Subject: MHI's Responses to US-APWR DCD RAI No. 740-5719 Revision 2 (SRP 06.02.02)

**US-APWR Design Certification
Mitsubishi Heavy Industries, Ltd.
Docket No. 52-021**

RAI NO.: NO. 740-5719 REVISION 2
SRP SECTION: 06.02.02 – Containment Heat Removal System
APPLICATION SECTION: 6.2
DATE OF RAI ISSUE: 4/26/2011

QUESTION NO.: 06.02.02-64

Figure b-1 Film Condensation at Structure Surface

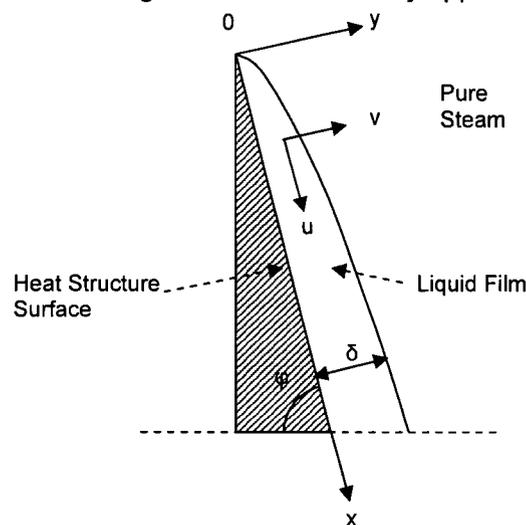
- o Condensate water on containment surfaces – Equation listed for film condensation correlation used to calculate film thickness could not be readily verified (reference in Japanese) and was not found in standard textbooks on heat and mass transfer. Appropriate reference and justification should be provided for the applied methodology and selected input values. Film thickness will be a function of the surface height. Justify estimated vertical surface area and corresponding heights

Condensate film thickness was calculated from Eq. 11 in the holdup volume calculation based on the fluid conditions. The calculation follows the methodology of theoretically solving the Nusselt film heat transfer correlation, which is widely known and is referenced from Reference 4 and 5.

Assume constant condensation and liquid flow on structure surfaces (Figure b-1).

By Eq.11, condensation liquid thickness on the surface of the heat structure is predicted. The height used for this calculation was 40 meters (about 130 feet), and the resulting condensation film thickness (based on 40 meters height) was applied to all surfaces. The vertical portion of containment from second floor level (EL 25'-3") is about 129 feet. If the vertical height (x) increases, the liquid film thickness also increases as shown in Eq. 11. However, the liquid thickness calculated based on a 40 meter height was conservatively applied to all surfaces.

The vertical surface area of the containment was calculated using "Concrete Outline Drawings" which indicate the frame shape of the building and the dimensions. Vertical area was extracted from the drawings, and a 5% margin was added to the total area.
